## Historic Landmarks and Preservation Districts Commission

### Report to the Committee

**Case No:** 21-COA-0204  
**Classification:** Staff Review

**Property Address:** 1215 S. 28<sup>th</sup> St.

*Proposed design for side facade mural*

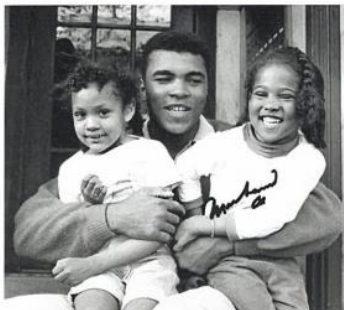
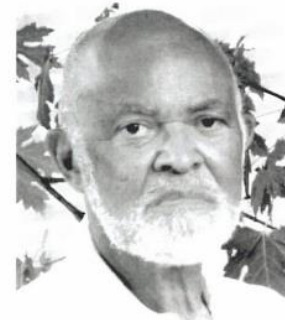
The proposed work generally meets the Parkland design guidelines for **Paint** and **Masonry**. It is to be painted in sections on the south side brick wall and is more modern brick than the front façade, which is still early 20<sup>th</sup> century brick. It will not cover the entire wall. The side has also been altered over time with the addition of various windows, doors, and brick patching. A very faded ghost sign is present, and there are portions of the wall that have been painted over to cover graffiti. Staff does not feel the brick will be significantly damaged or compromised by the painting of the mural.

The mural design is dynamic with themes that tie well to the building use and the Parkland neighborhood. A new park area is planned for the space directly across the alley, and the mural will help mirror the community aspect of these plans. The proposed text is simple and easy to read. Overall, Staff finds the mural to be appropriate for the site, district, and neighborhood.

On the basis of the information furnished by the applicant, the application for a Certificate of Appropriateness is **approved with the following conditions**:

1. **If the design or materials change, the applicant shall contact staff for review and approval prior to any work taking place.**
